Re: Menaul & Vassar Warehouse
2500 Phoenix Ave NE
Traffic Circulation Layout
Engineer's/Architect's Stamp 10-18-24 (H16D156)

The TCL submittal received 10-29-2024 is approved for Building Permit by Transportation. A copy of the stamped and signed plan will be needed for each of the building permit plans. Please keep the original to be used for certification of the site for final C.O. for Transportation.

**MENAU & VASSAR
SITE PLAN
2500 PHOENIX AVE NE 87107
ALBUQUERQUE, NM
PROJECT #2267**

REVISION	DATE
DATE	10/18/2024
SHEET NUMBER	AS-1.0

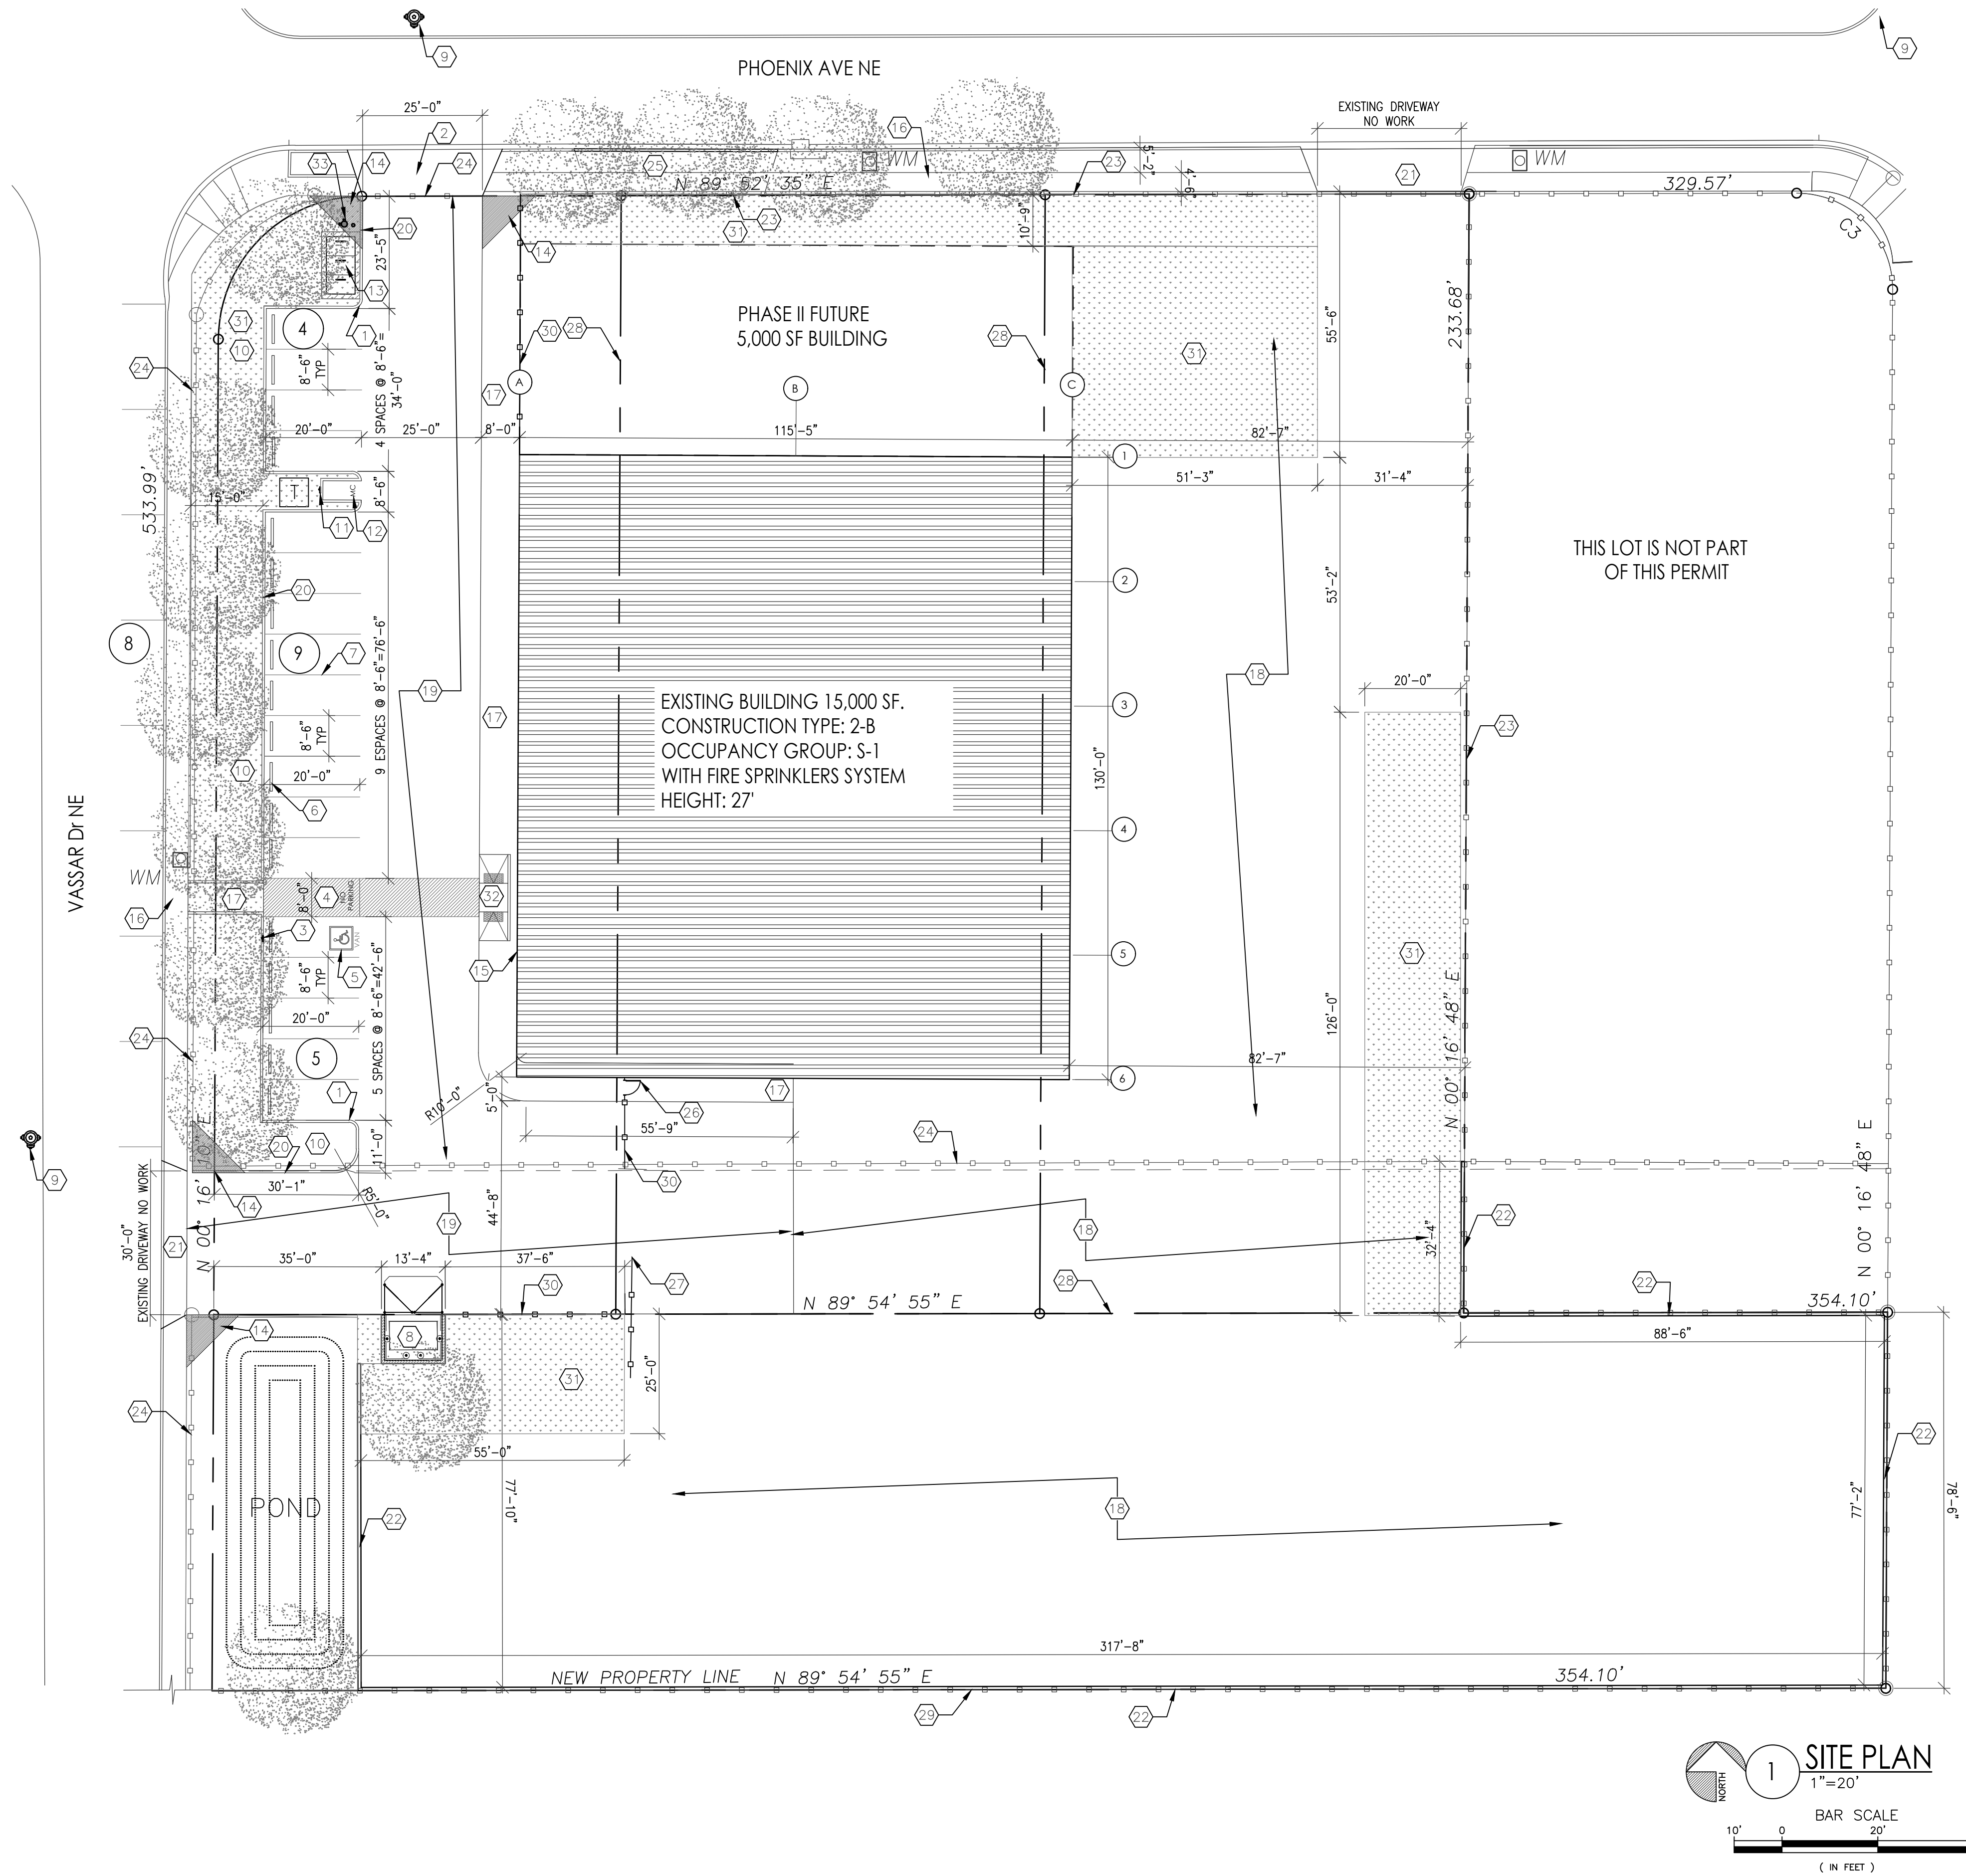
**Approval Condition : Lot lines
are removed per Note-28**

SHEET NUMBER
AS-2.0

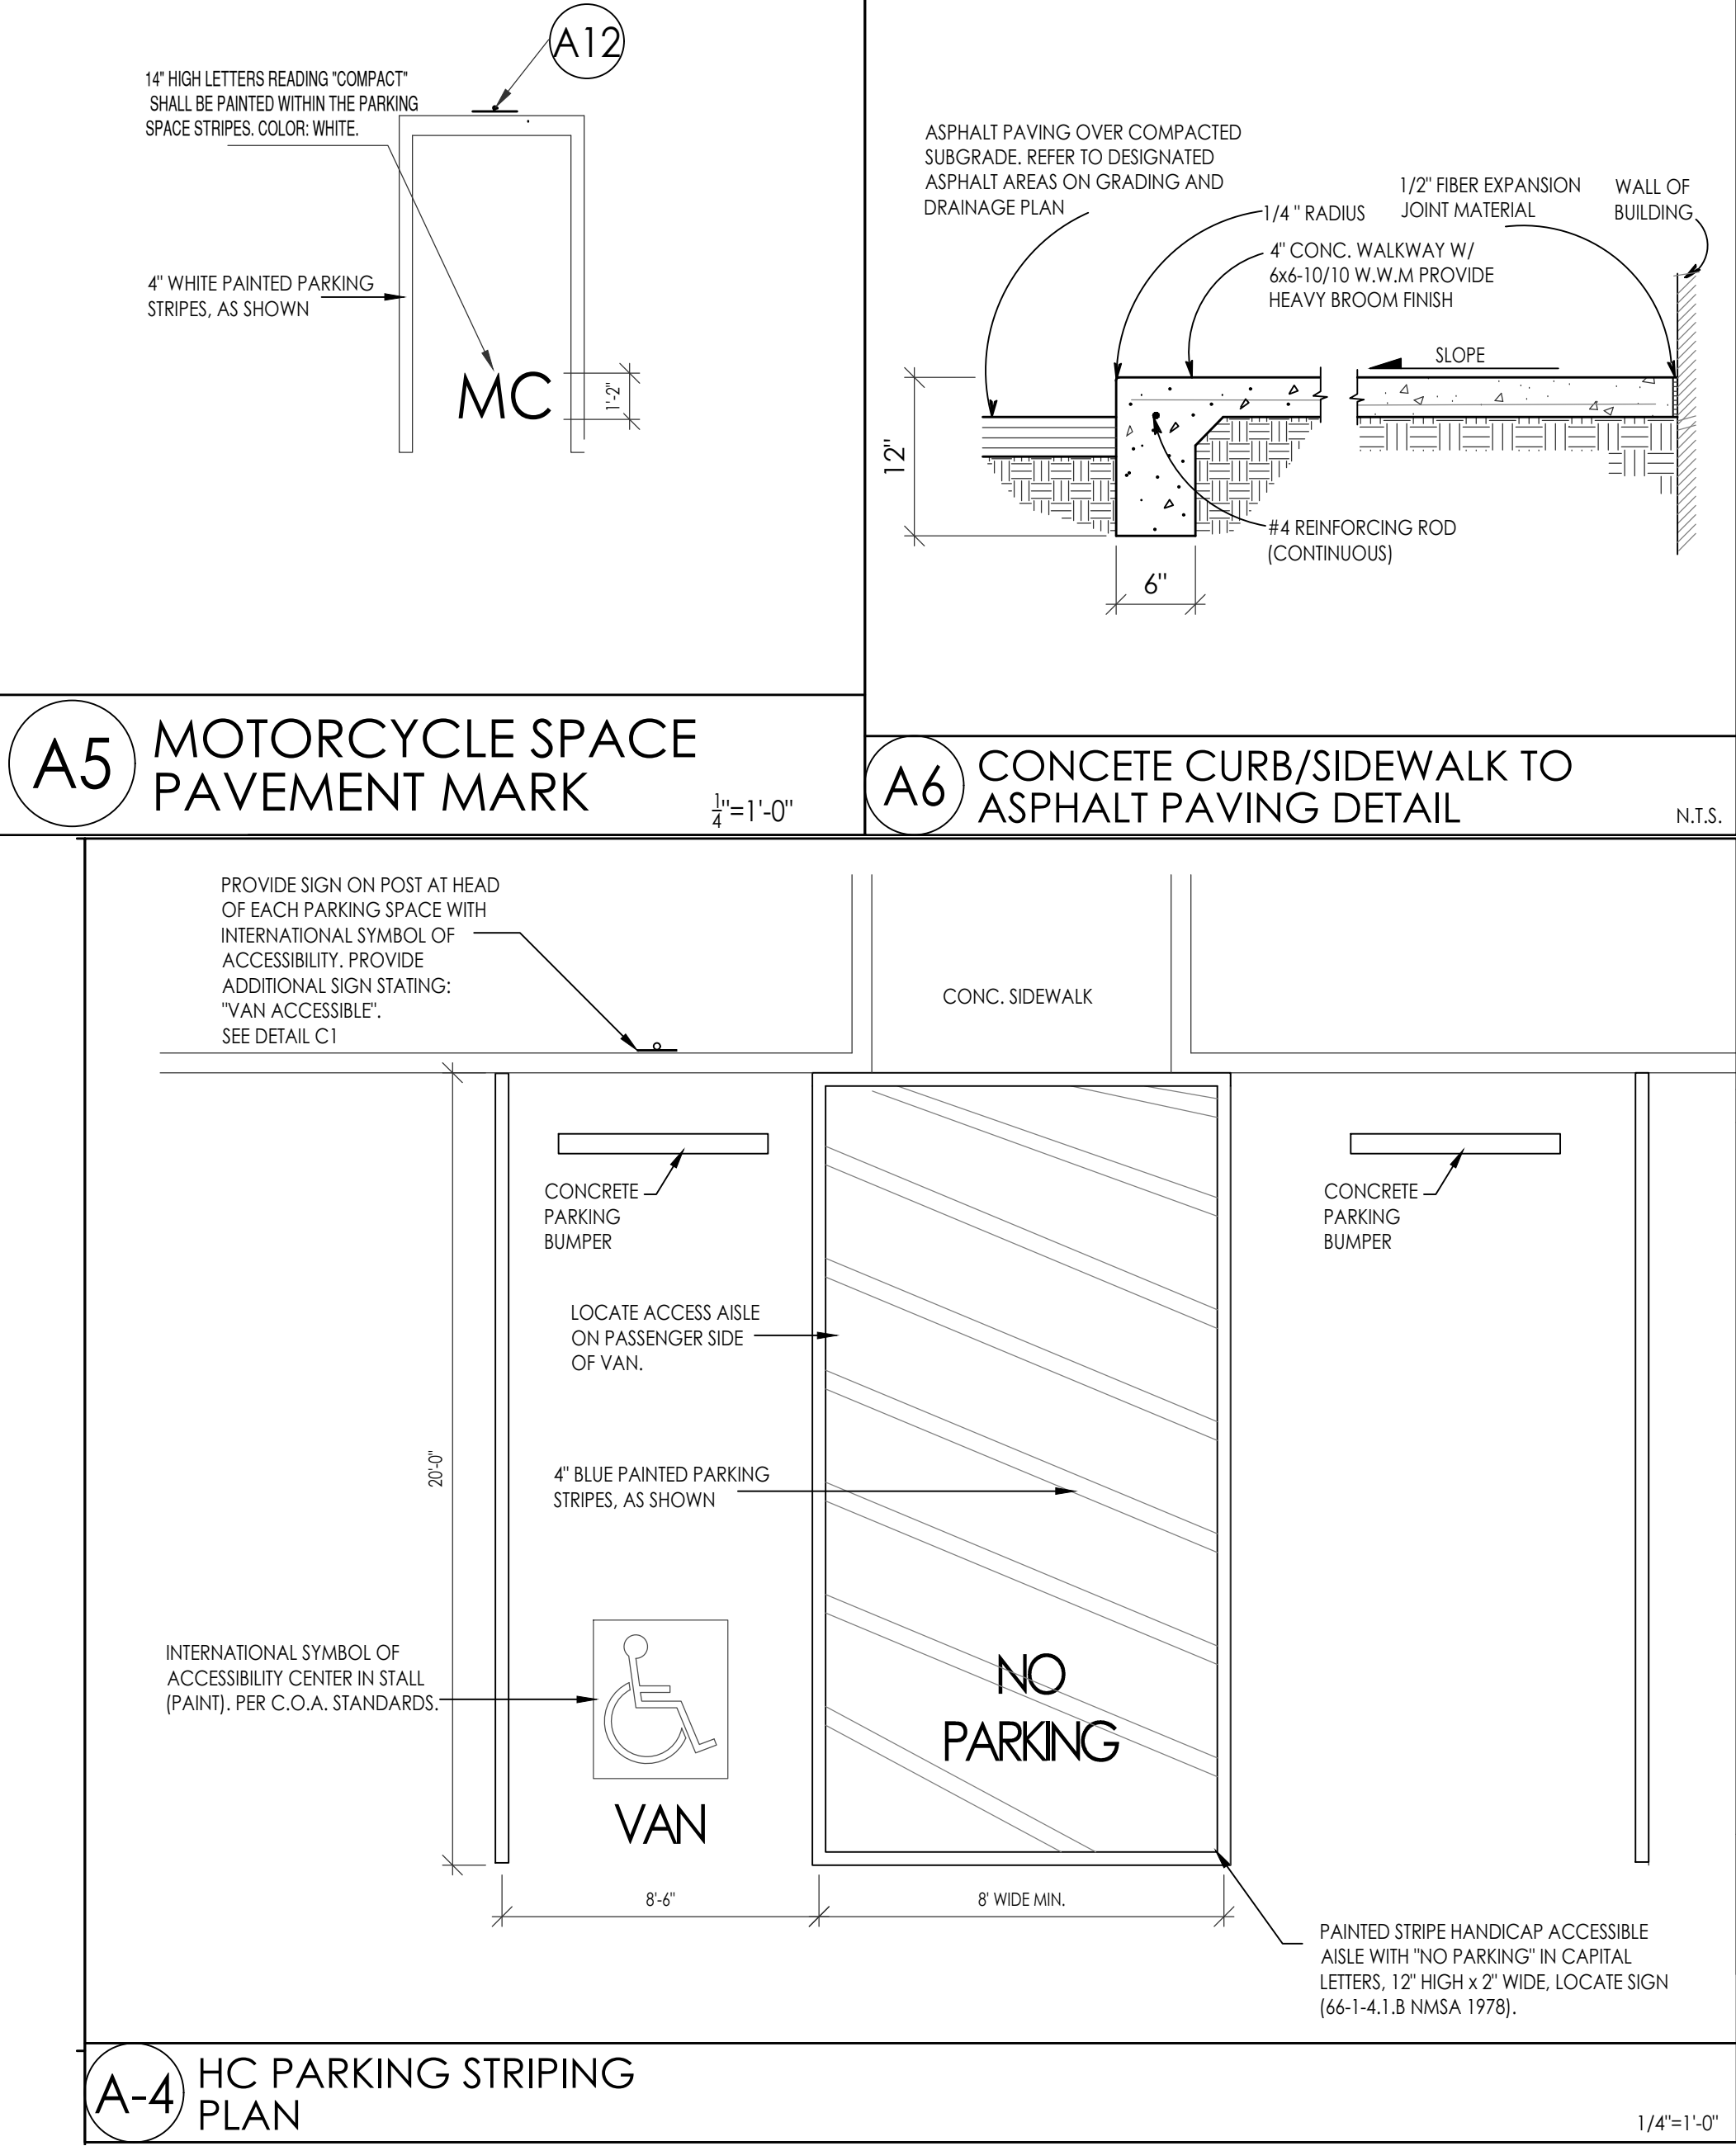
Approval Condition : Lot lines are removed per Note-28

F-1

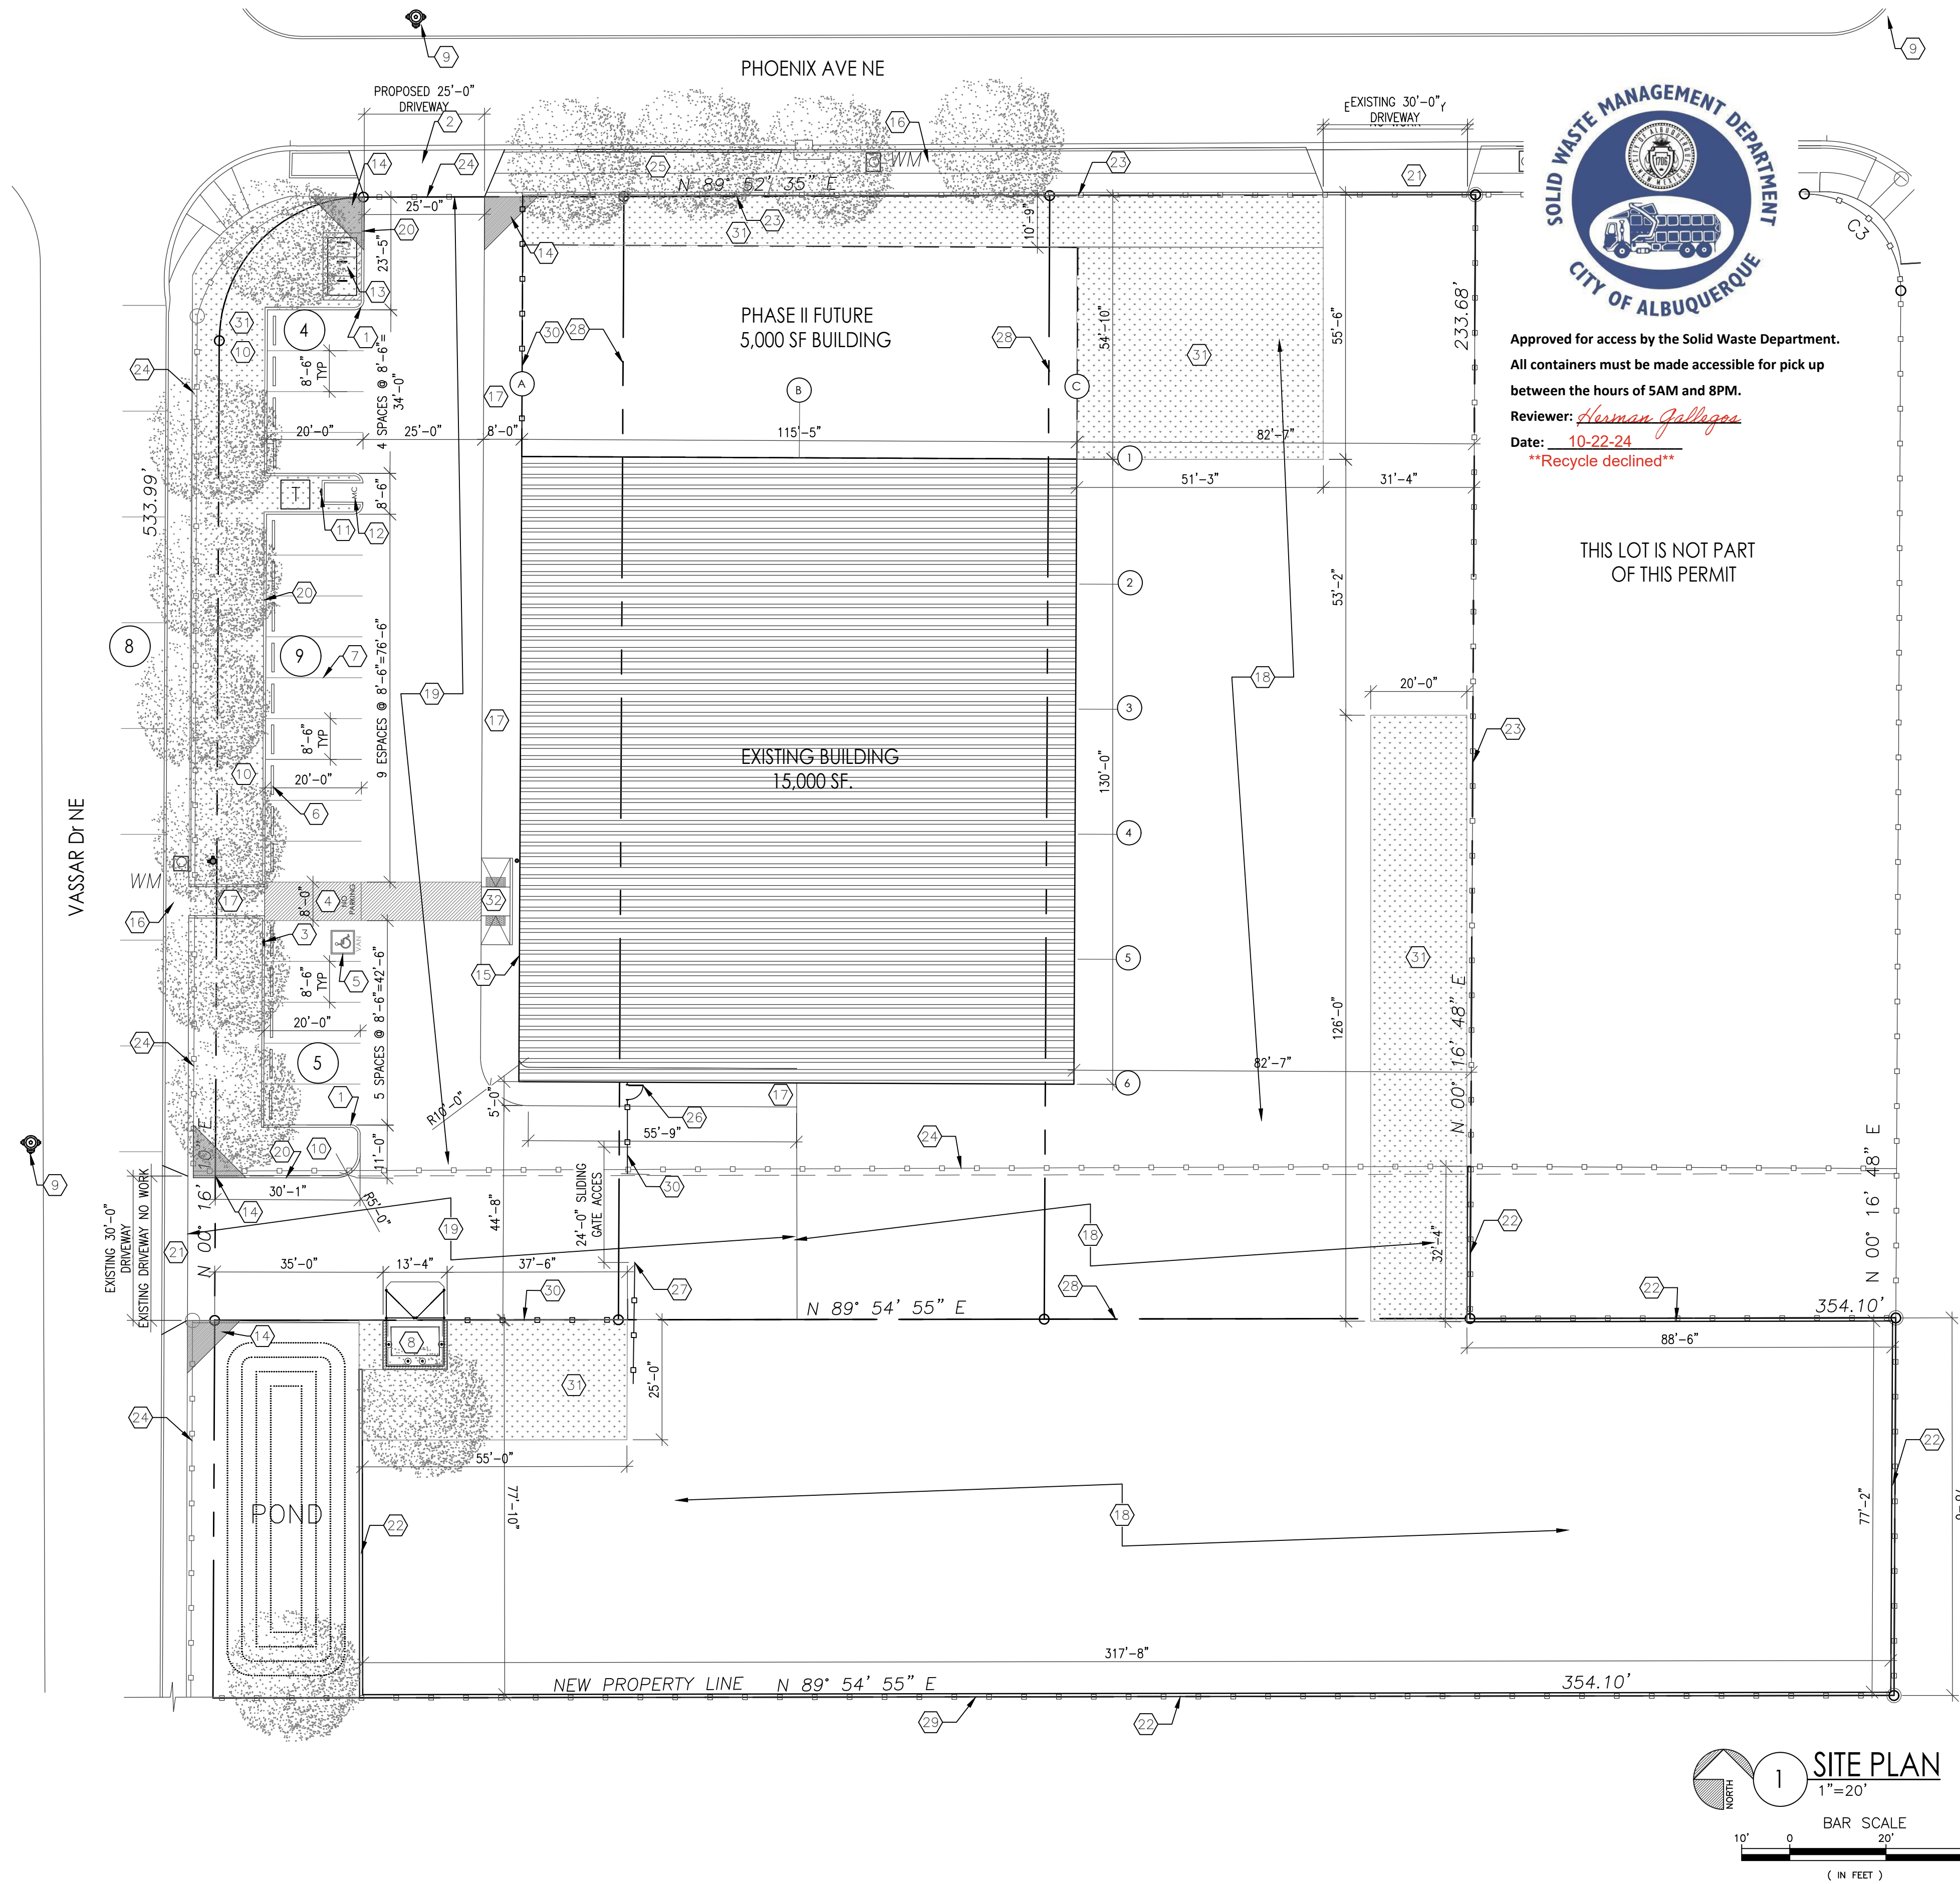
Approved for access by the Solid Waste Department.
All containers must be made accessible for pick up
between the hours of 5AM and 8PM.
Reviewer: *Herman Gallagos*
Date: *10-22-24*
****Recycle declined****
